PLANNING, ZONING, & BUILDING DEPARTMENT  
PZ&B Staff Memorandum: Town Council Development Review

SUBJECT: ZON-22-132 (ARC-22-200) 165 BRADLEY PL (COMBO)

MEETING: NOVEMBER 09, 2022

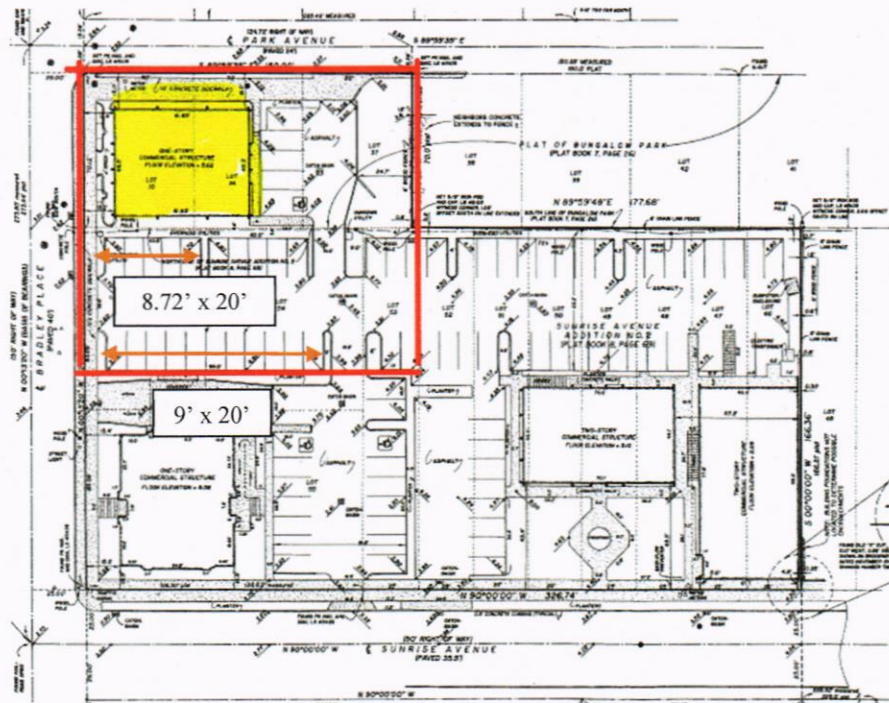
The proposed site plan illustrated in the rendering below will amend the current site plan in order to provide an outdoor play area east of the subject building currently designated for parking and site access. This modification will result in a loss of five (5) parking spaces, including one (1) ADA accessible space. To accommodate the loss of one (1) handicapped accessible parking space, a new one is proposed in the south parking area along the building frontage. The number of parking spaces proposed requires a total of four (4) accessible parking spaces and five (5) are being provided. With regard to the existing on-site parking area that was constructed in 1980, the typical parking stall meets the Code required nine (9)-foot by 20-foot dimension. In the as-built survey, five (5) spaces were found to be just under in width than current Code requires (8.72 feet).

As to the proposed landscape and hardscape, with the removal of the access from Park Avenue, a new six (6)-foot high hedge is proposed along Park Avenue. Displayed in the North Side Elevation below, the landscape hedge will provide a buffer to limit visibility and provide security from Park Avenue to the proposed enclosed playground area. The site plan delineates the proposed playground will both natural and synthetic turf and shade elements. The proposed artificial turf will be installed over the existing asphalt parking area.

Pursuant to Code Section 66-313, in all zoning districts, artificial turf shall be reviewed and may be approved in accordance with the ARCOM Project Designation Manual and may be installed in limited areas of rear and side yards, or as a driveway accent in any yard, example to include strips of artificial turf placed between stone or concrete driveway pads. Artificial turf shall not be installed in any front yard areas, except as a driveway accent, or in any areas visible from the public right-of-way.
